**Change Notification #: 110294 - 00**

**Change Title: Intel® Server System SR1695WB,  
PCN 110294-00, Product Design,  
Change the fan cable and top cover  
screw**

**Date of Publication: October 26, 2010**

Figure 1. Location of the cable clip

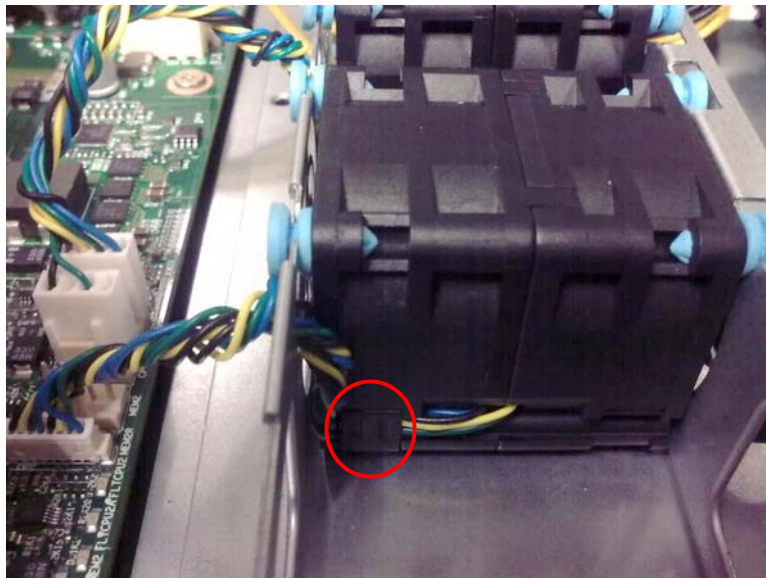
- 1) Remove the cable clip (Figure 1) and add protective tape around the fan cable to better protect it;
